**Village Plan Commission
Meeting Agenda
Monday, October 10, 2022
5:30 P.M.**

TO: Intergovernmental Agreement (IGA) Joint Commission & Village of Somers Plan Commission
FROM: Luke Godshall, Senior Land Use Planner
RPT DATE: 09-27-22
MTG DATE: 10-10-22
RE: Somers Bobcat

J1 EXTERIOR ELEVATIONS - NORTH FACADE

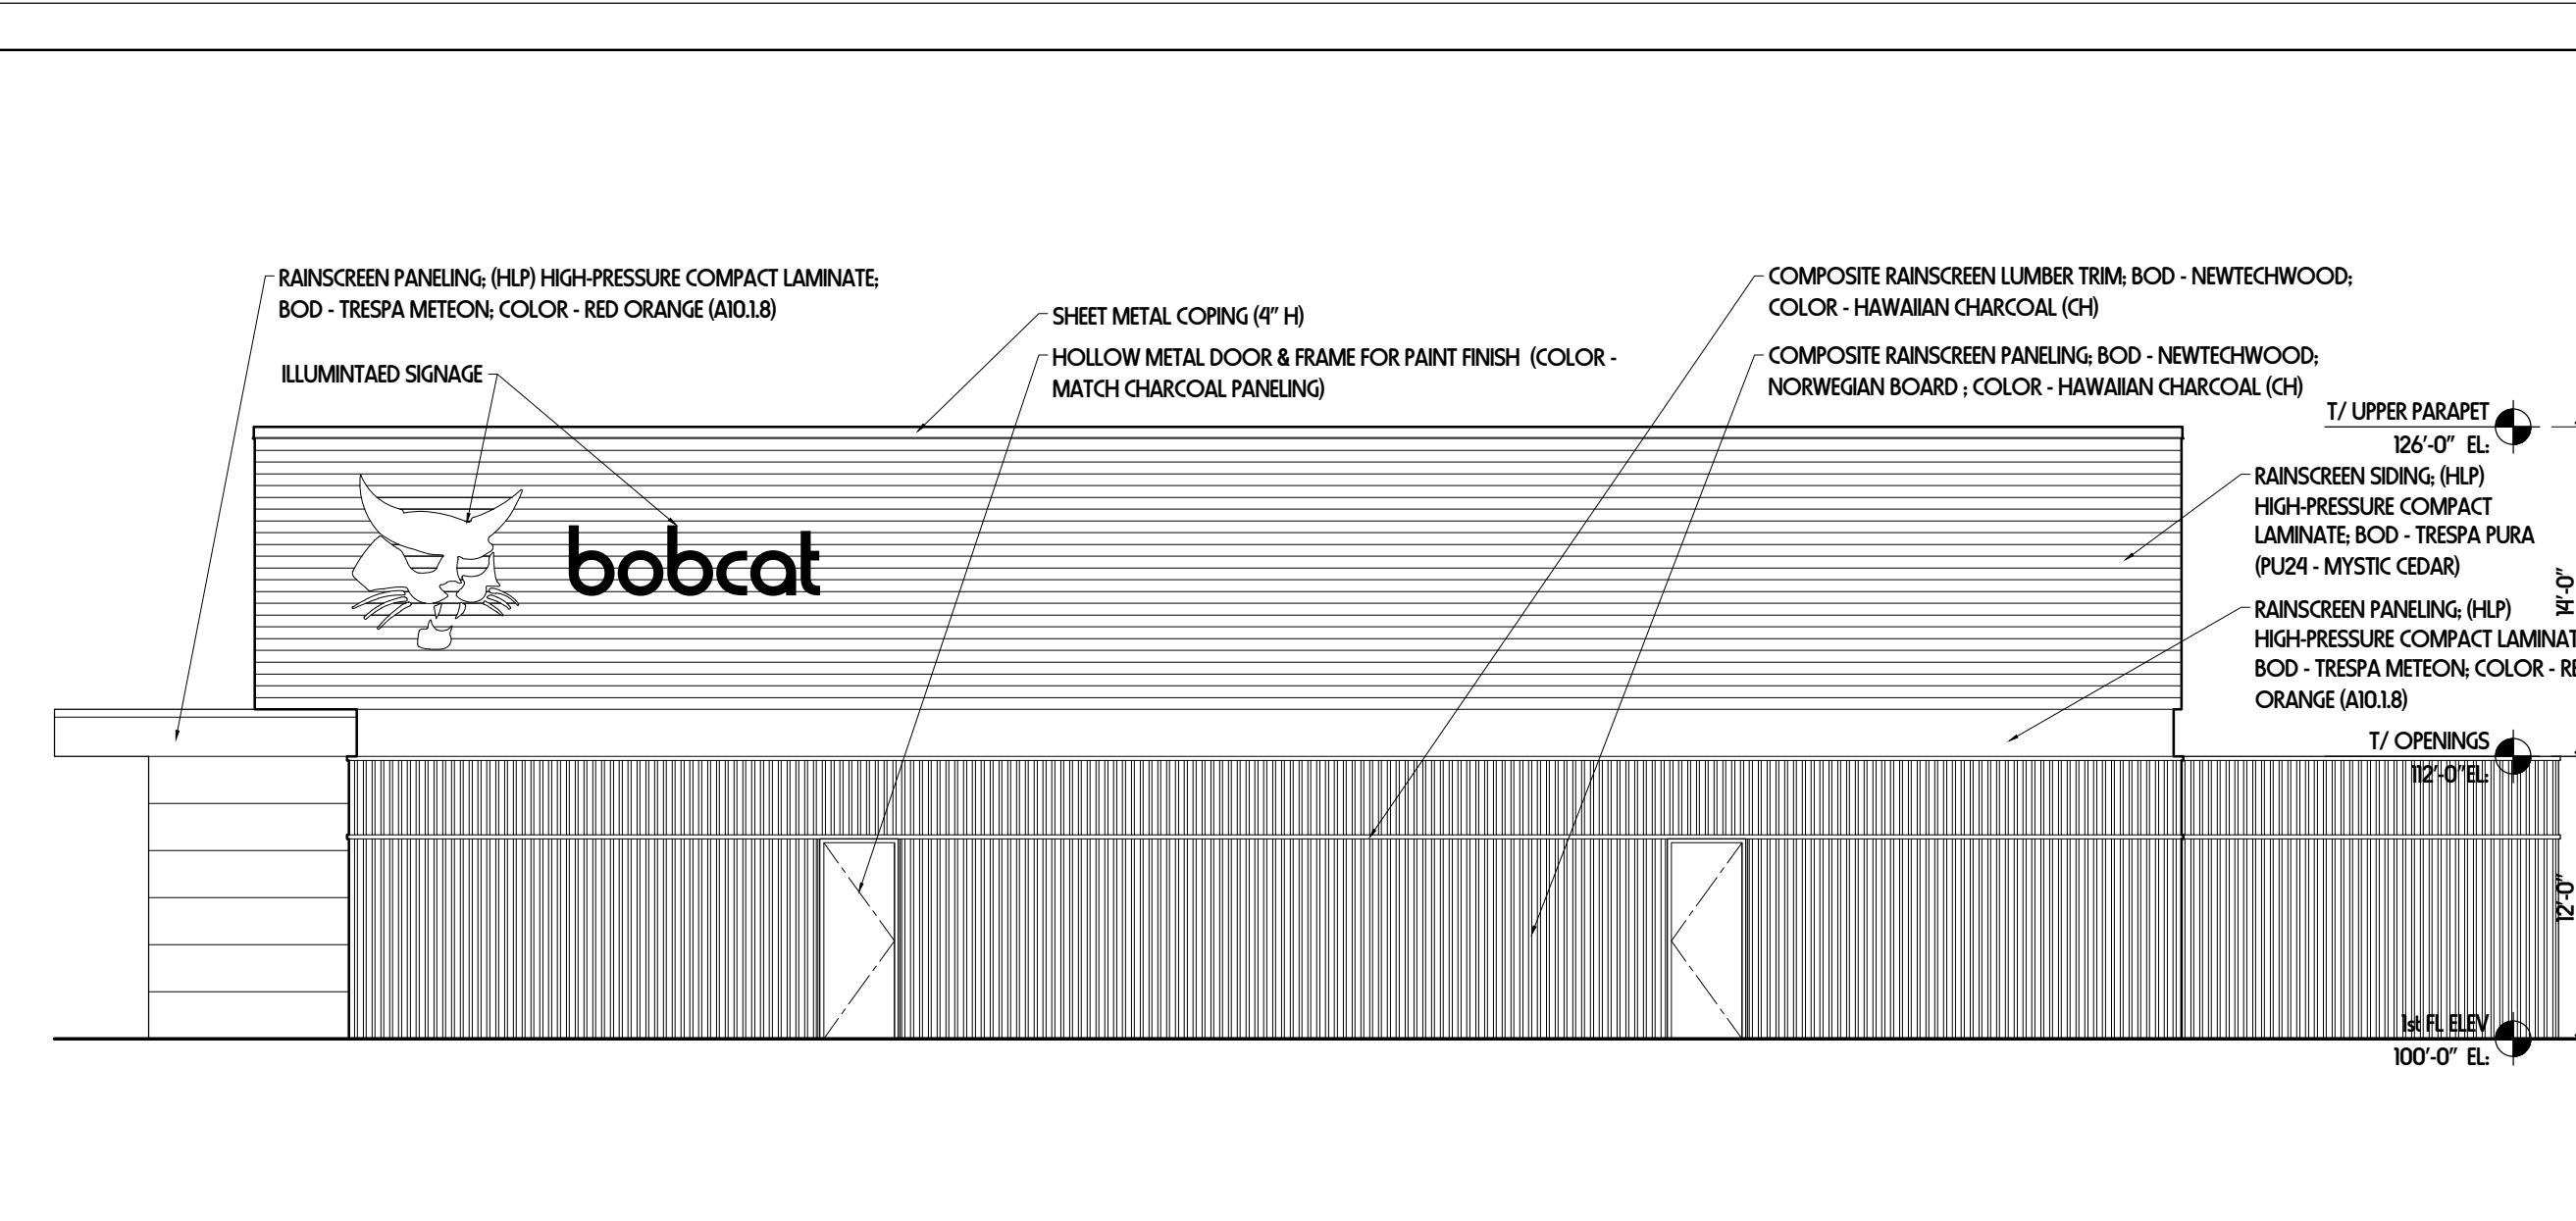
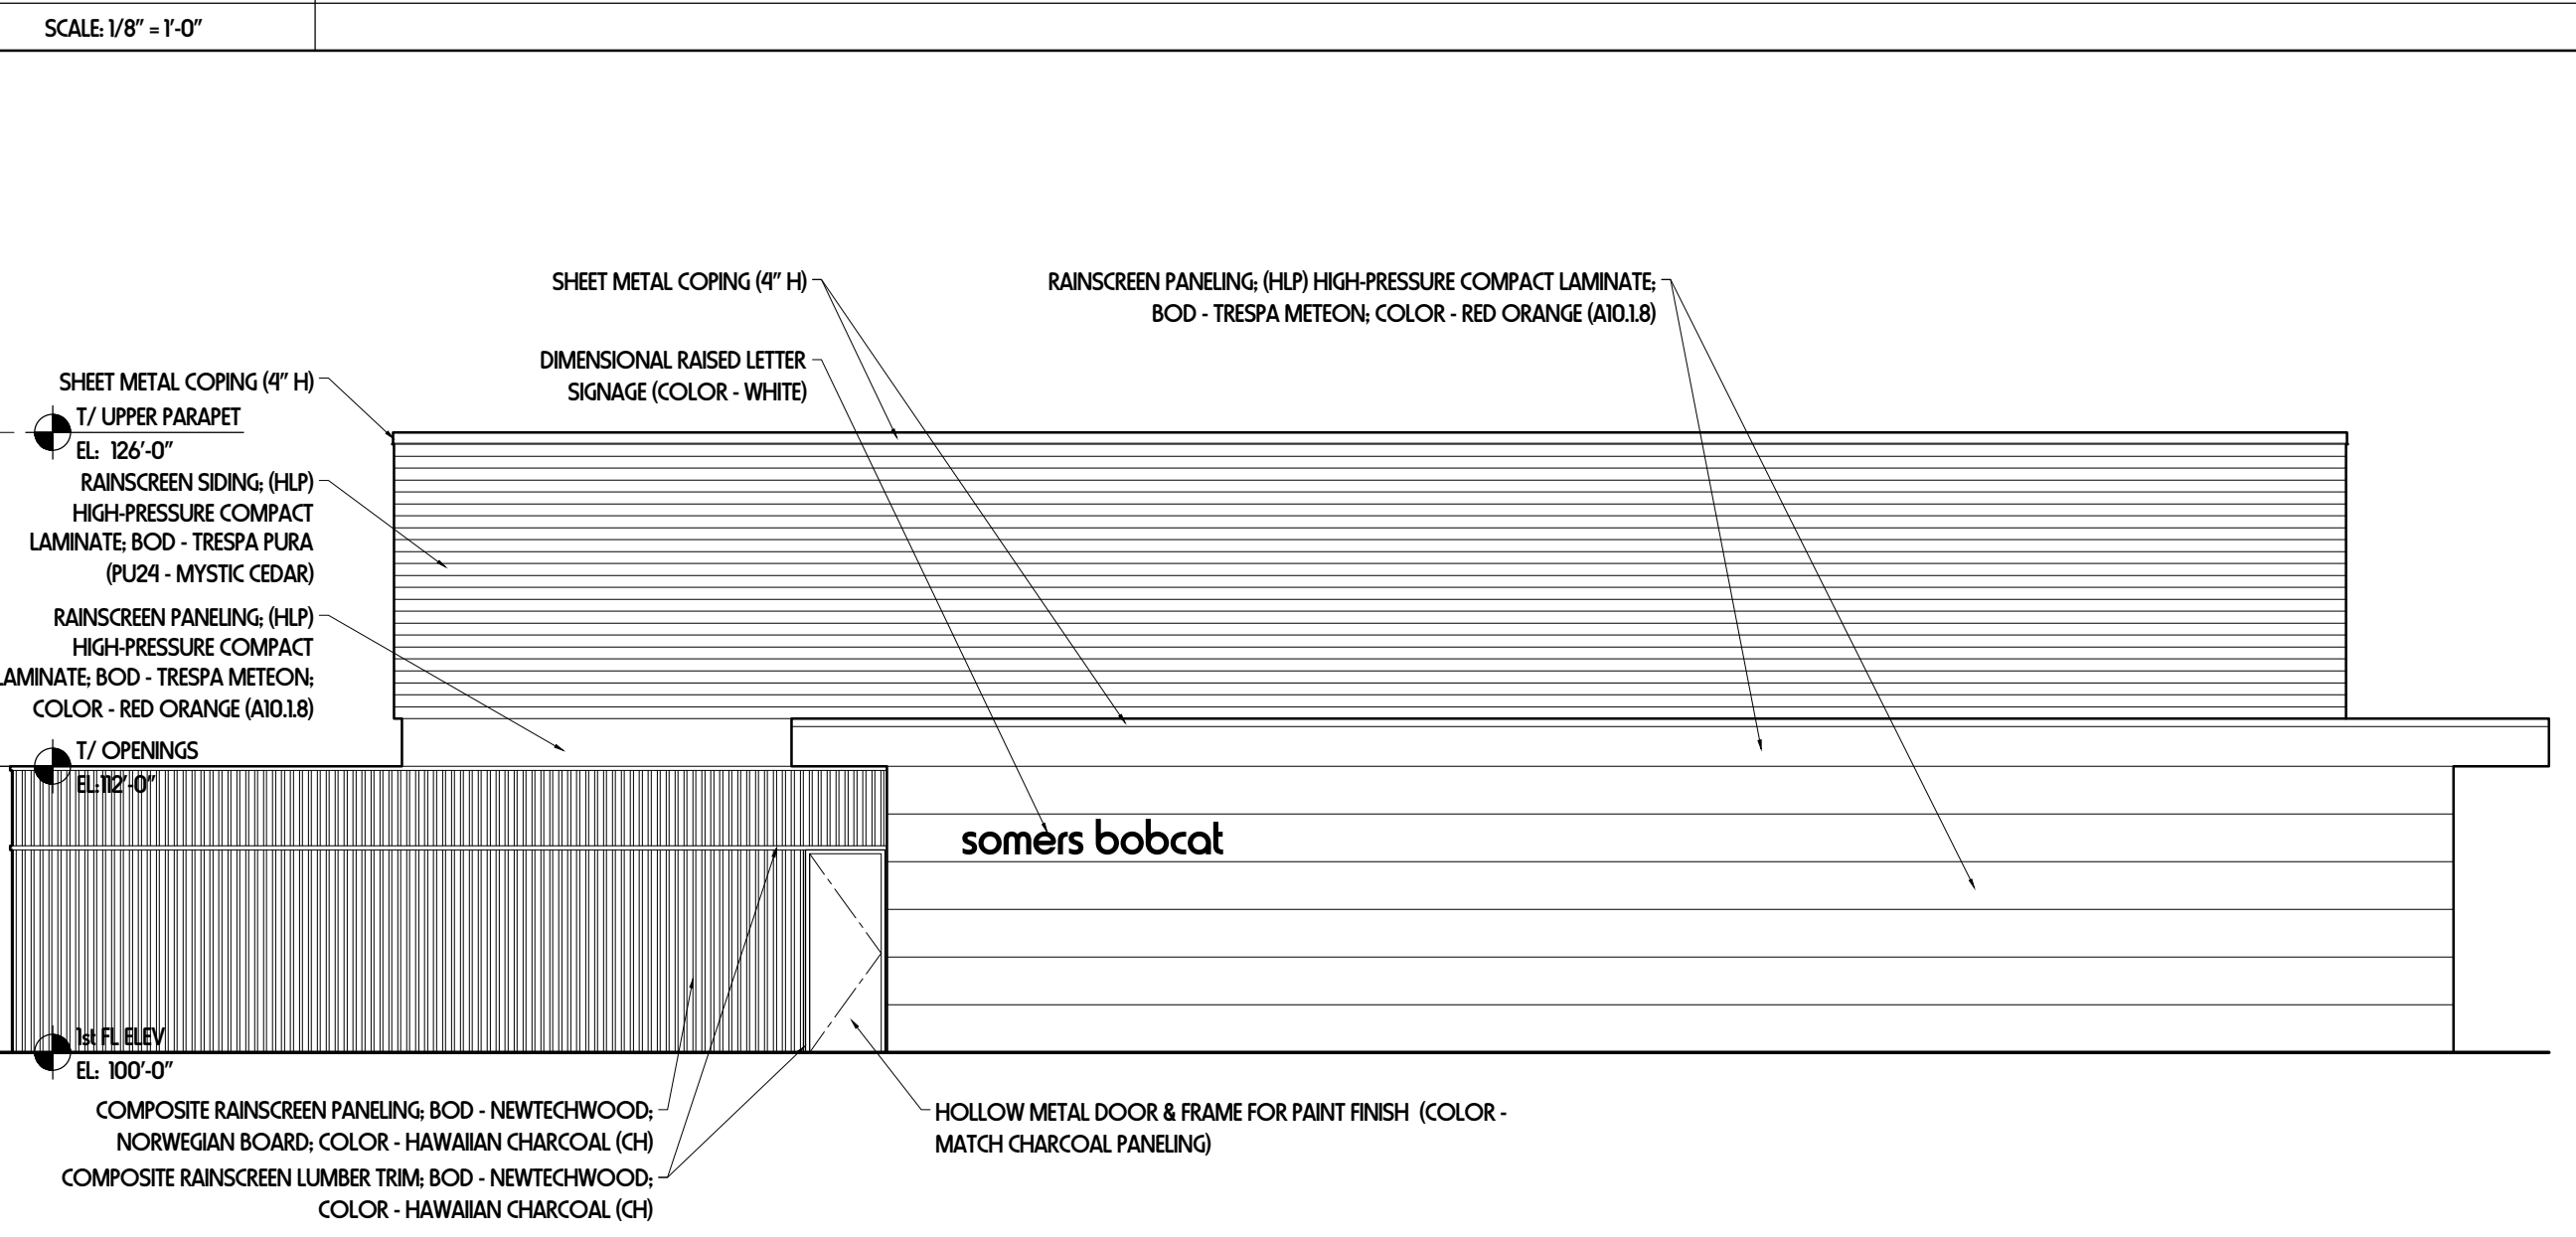
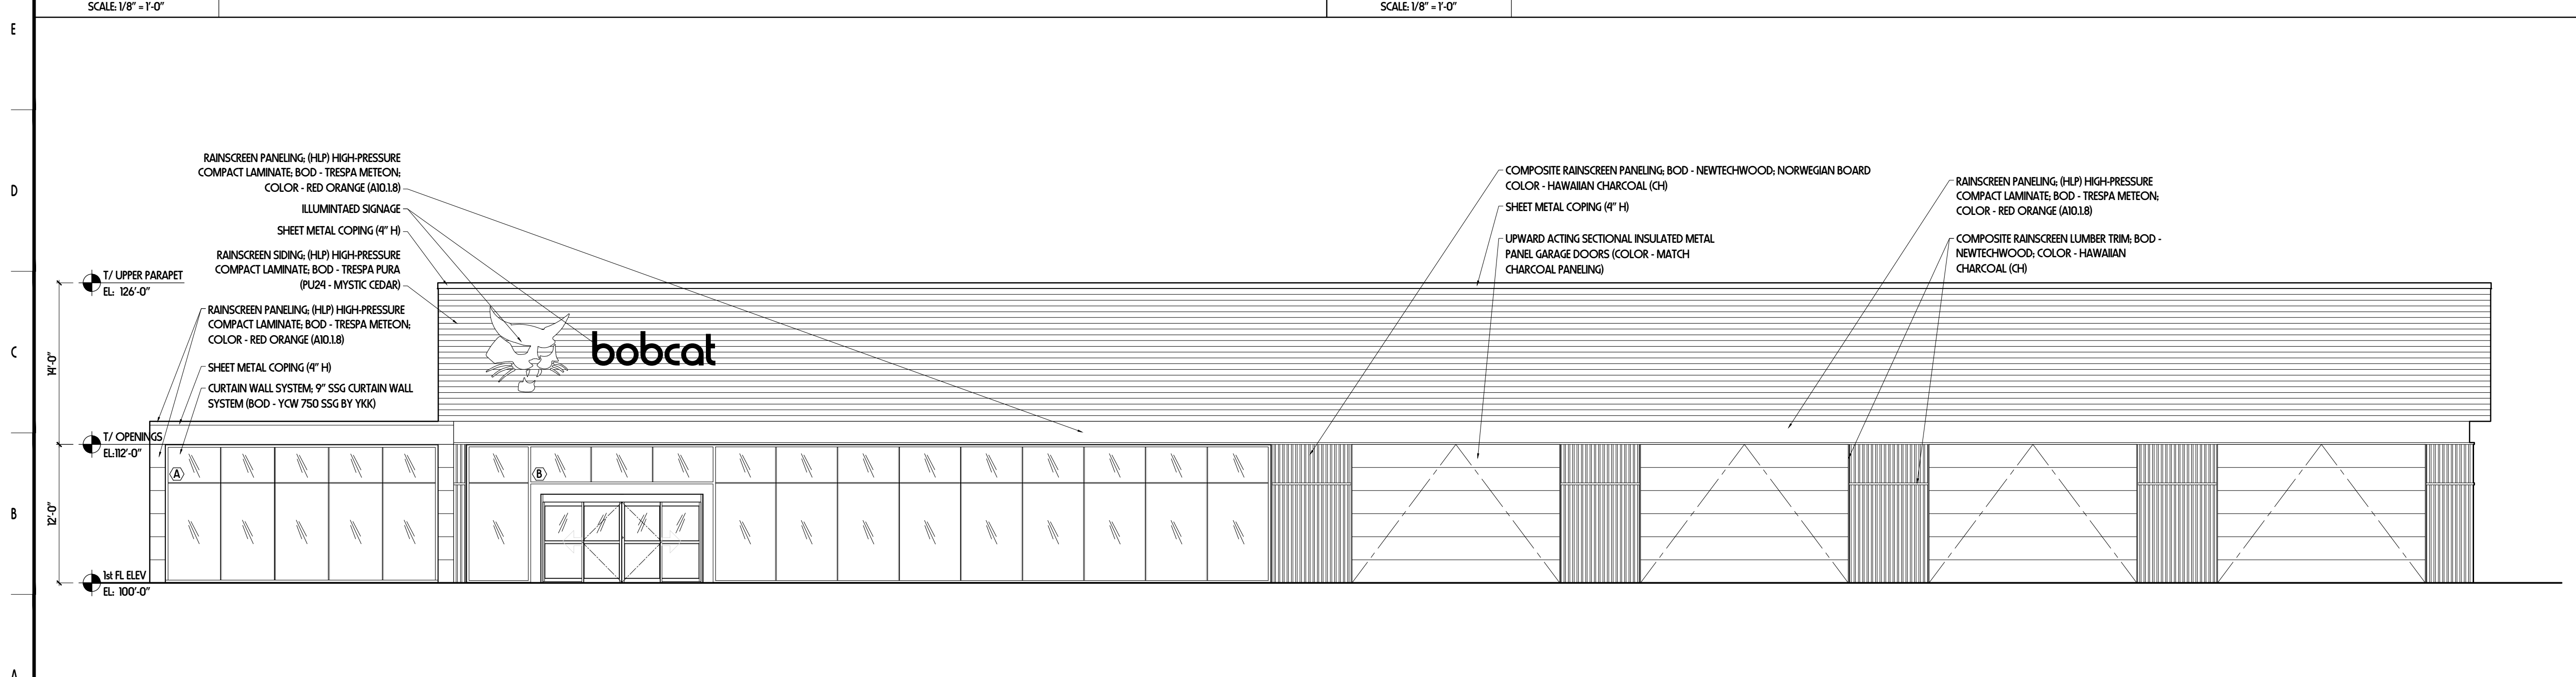
The exterior building elevations indicate the building would be composed of a variety of materials on all four elevations. Although the elevations do indicate the names of colors to be used, color elevations and color perspective drawings were not included with the updated plan set. The submitted building plans also do not indicate the location of auxiliary building equipment such as heating, ventilating, and/or air-conditioning equipment, which are required to be screened appropriately. It is recommended that updated or additional plans be submitted to show these details.

5. The Petitioner shall submit color building elevations and perspective drawings, as well as plans that indicate the location of any auxiliary building equipment such as heating, ventilating, and/or air-conditioning equipment and how this equipment will be screened.
